**Airways New Zealand submission to the
Civil Aviation Authority's
2016 Waikato and Bay of Plenty Airspace Review**

**Prepared by: John Wagtendonk
Policy, Standards and Safety Improvement**

20 November 2015

Rotorua CTR and CTA Proposal

DRAFT RO CTR Amendment
Version 4 30 October 2015

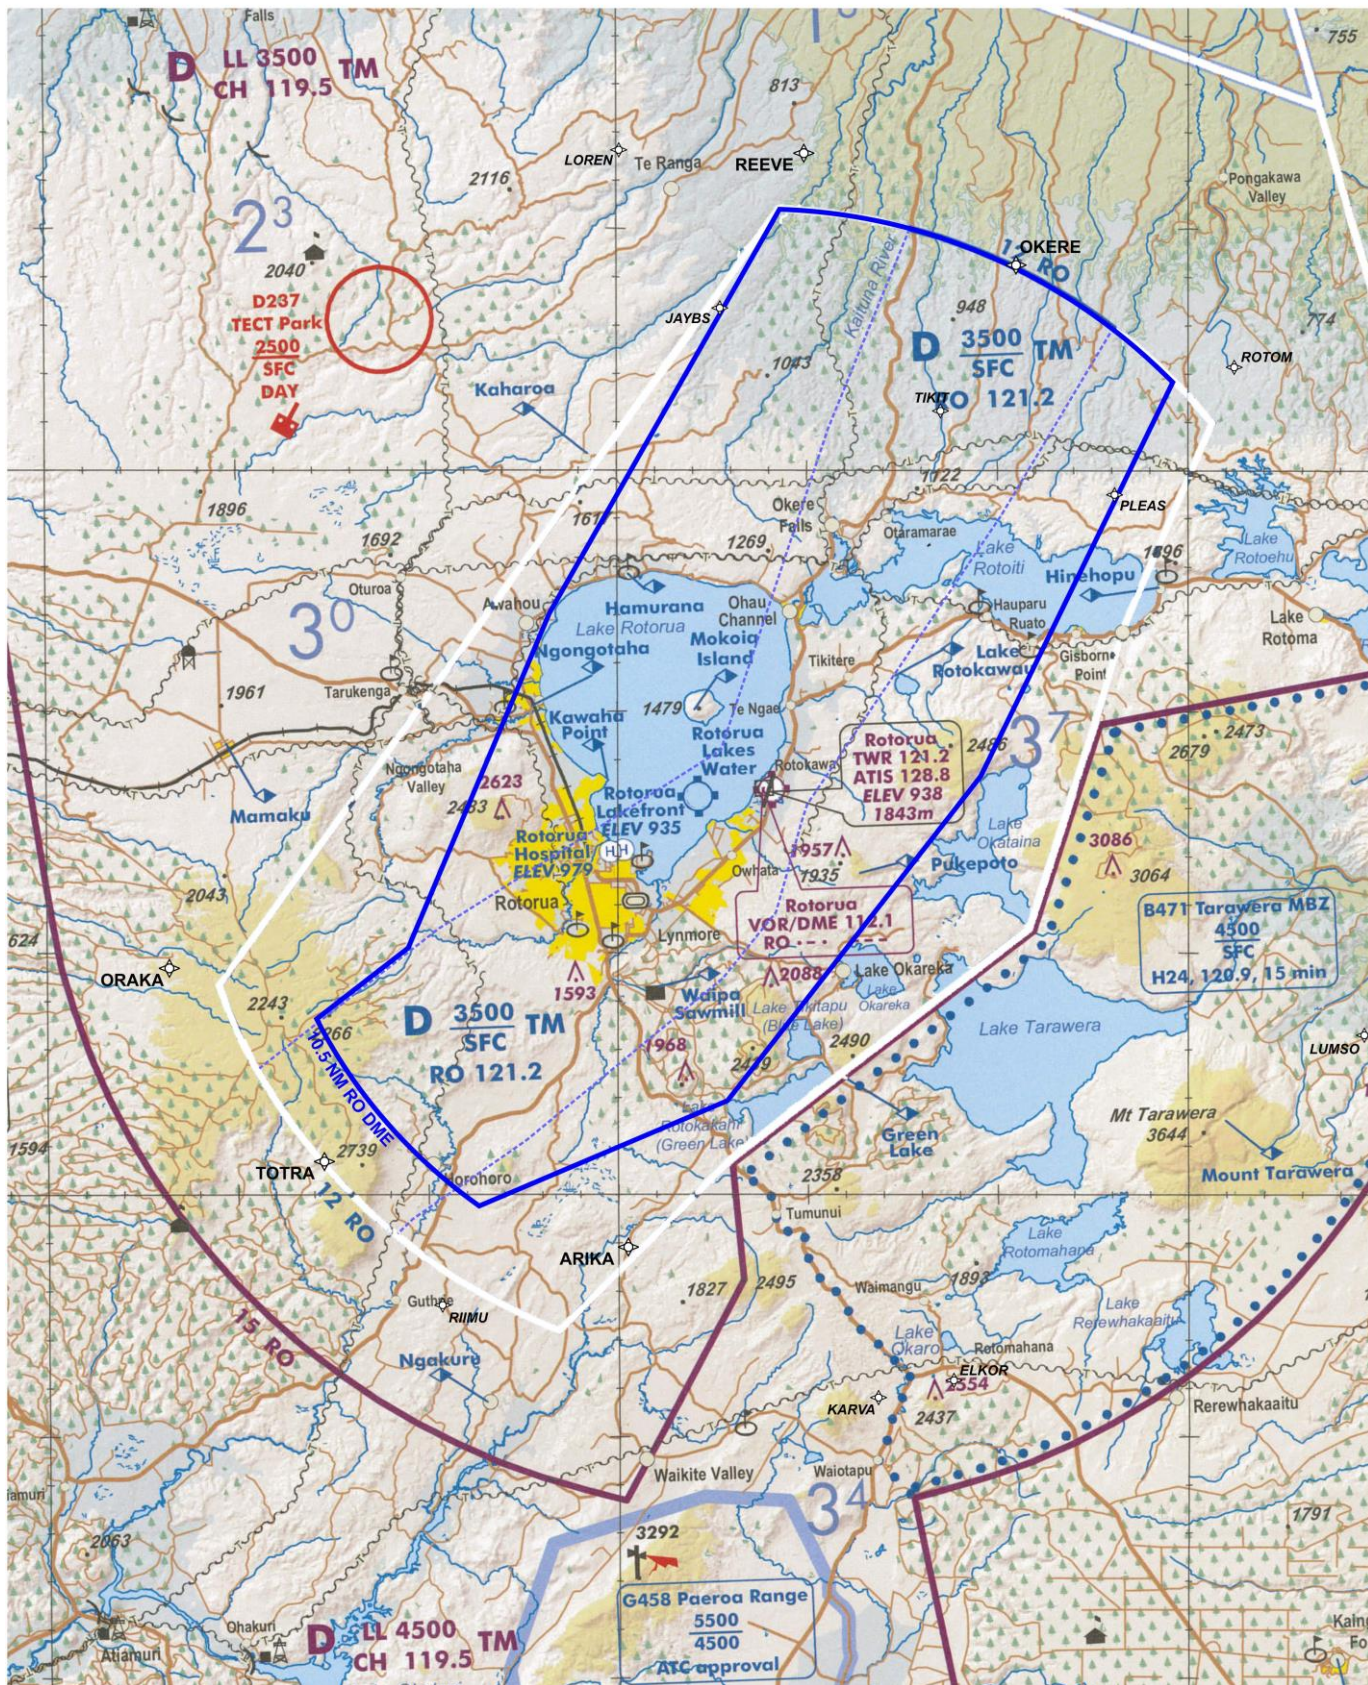
NOTES: Requires VOR/DME A approach to be raised so it turns inbound at 4000ft (current 3900ft)
Requires VOR/DME RWY 18 approach to be lengthened so it turns inbound at 12 NM at 4000ft.
This design does not contain VOR Departures other than OKERE3 and TOTRA4 to 4000ft

1. The upper level of DRAFT CTR remains at 3,500ft AMSL.
2. Changes to the RO CTA LL 3500ft (NZA447) and RO CTA LL 4500ft (NZA244) are necessary to contain proposed new PBN IFPs at RO and TG. These are discussed from page 4.
3. Airspace containment criteria applied

4. The width of the CTR is primarily determined by containment of the proposed new RNAV SIDs off RWY 36. These maintain RWY centreline to 8 NM then turn to the west/east- reaching 4,000ft just prior to the CTR boundary.

5. The CTR is wider than the Instrument Sector for the existing approaches. This design assumes that any new PBN approaches would follow the same paths as the existing RNAV approaches.

6. This CTR design requires the existing RO VOR/DME 18 approach to be changed so that the approach turns inbound at 4,000ft or above. This is so that the CTR only needs to contain the inbound path and not the outbound and base turn of the teardrop approach. It is expected that the amended approach would retain the current 3.0° profile but it would need to have a longer inbound (and outbound) leg from around 10 NM.

7. This design would not fully contain the VOR RWY 18 approach outbound and base turn legs. The inbound leg would be fully contained once inside 12 DME RO. The existing CTR also does not fully contain the outbound and base turn legs - with the new CTR, containment would be very slightly less than current.

8. The width of the CTR is primarily determined by containment of the current Instrument Sector.

The proposed new RNAV SIDs off RWY 18 have a steeper climb profile requirement (6.3% = 383ft per NM) that reaches 4,000ft prior to turning off the RWY centreline – hence the CTR does not need to be wider to contain these SIDs.

9. This CTR design requires the existing RO VOR/DME A approach (for RWY 36) to be changed so that the approach turns inbound at 4,000ft or above. This is so that the CTR only needs to contain the inbound path and not the outbound and base turn of the teardrop approach. It is expected that the amended approach may need a very slightly steeper profile.

10. The width of the CTR contains Cat C circling to the west of NZRO (circling to the east is not permitted, nor is cat D circling)
11. The width of the CTR to the east of NZRO is sufficient for aerodrome operations.

12. The northern boundary of the CTR would be the same as the existing CTR boundary at 12 NM RO.

13. The southern boundary of the CTR is at 10.5 NM RO DME – not so far out as the existing boundary at 12 NM.

This boundary is primarily determined by the descent profile of the RNAV (RNP) Y RWY 36 approach and the default 300ft per NM profile (10.3 NM from RWY 36 Thr/elevation).

Diagram of extended RO CTA also depicting the holding pattern with protection area at OKERE and the holding pattern with protection area for the planned new waypoint TIKIT.

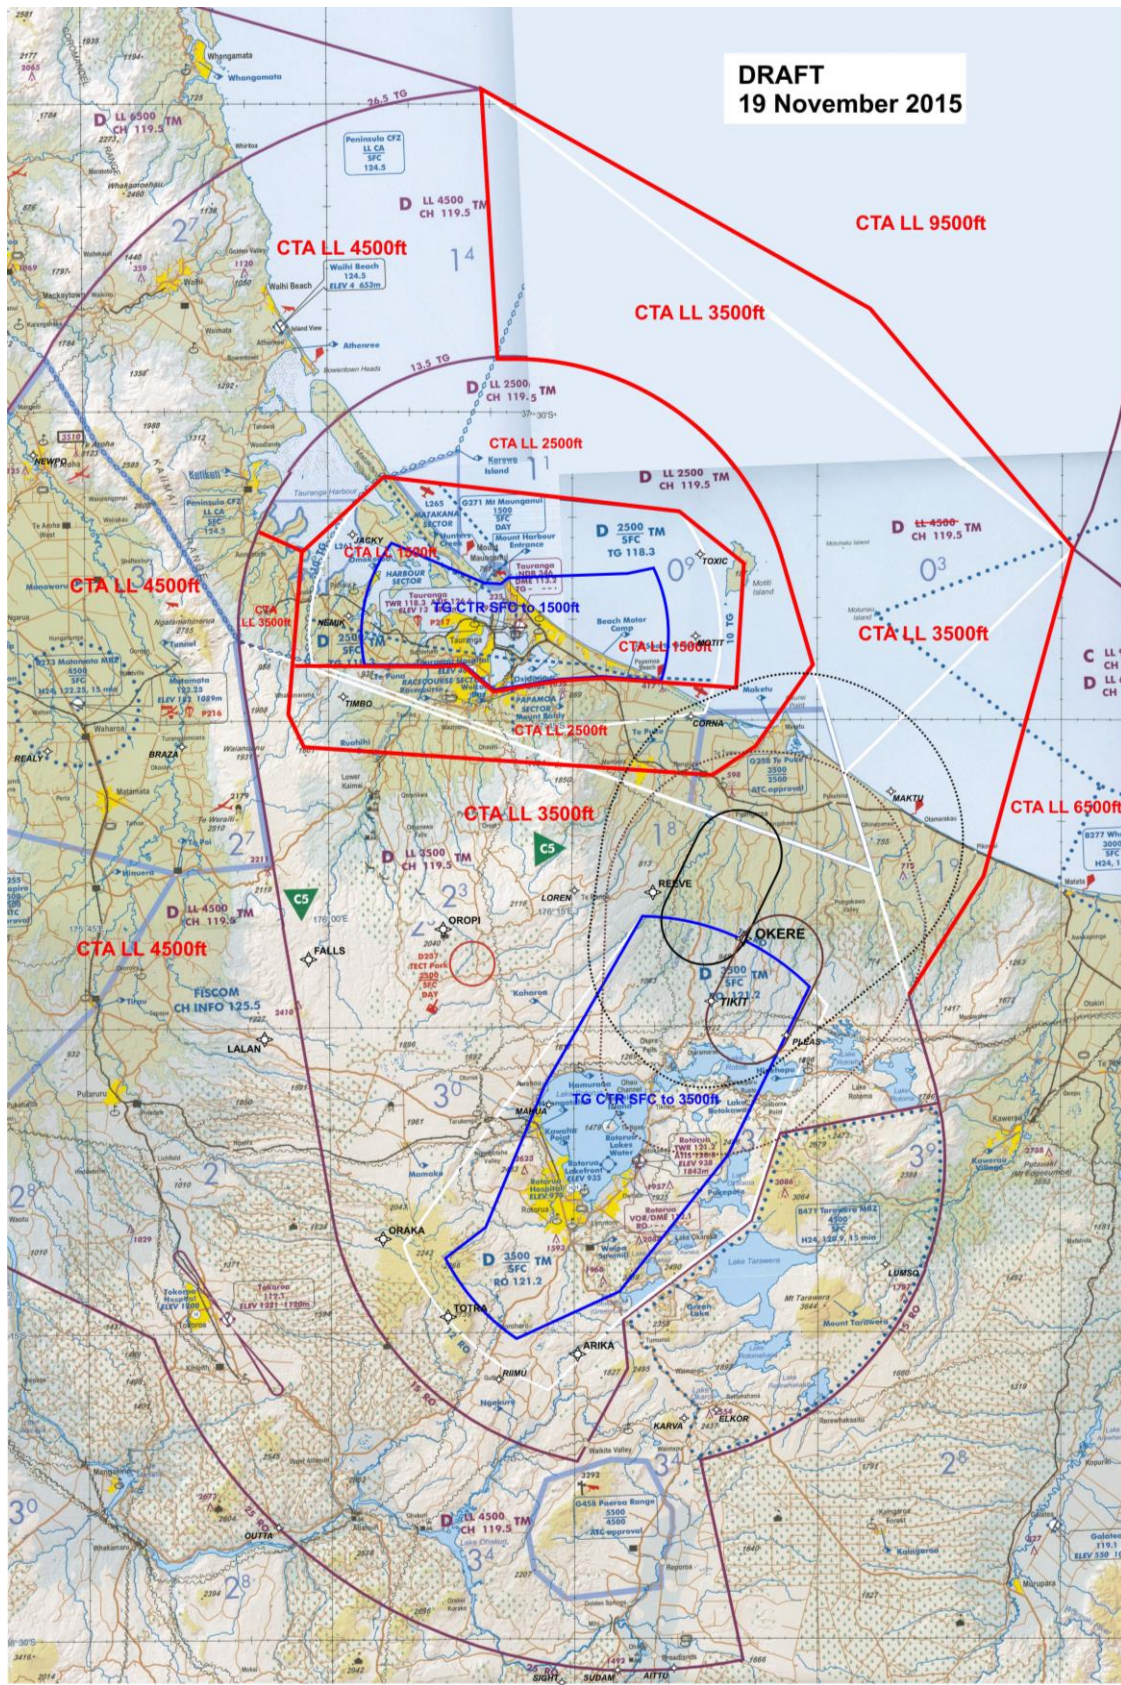
14. The draft new RO PBN approaches and the existing approaches utilise the existing holding pattern at OKERE, an IFR waypoint to the northeast of RO. This holding pattern is currently not fully contained at the 300ft per NM profile.

To provide full containment, it is proposed that the RO CTA LL 3500ft (NZA447) is extended as depicted on the diagram on the next page. This diagram also depicts the CTA and CTR changes required for TG.

Also, one of the new approaches utilises a new waypoint 8 NM from RWY 18 THR on the centreline. This waypoint is tentatively called TIKIT. There would also be a holding pattern at TIKIT. The extended CTA would also contain this holding pattern.

The extended CTA LL 3500ft would also provide containment for a new holding pattern to the northeast of Tauranga.
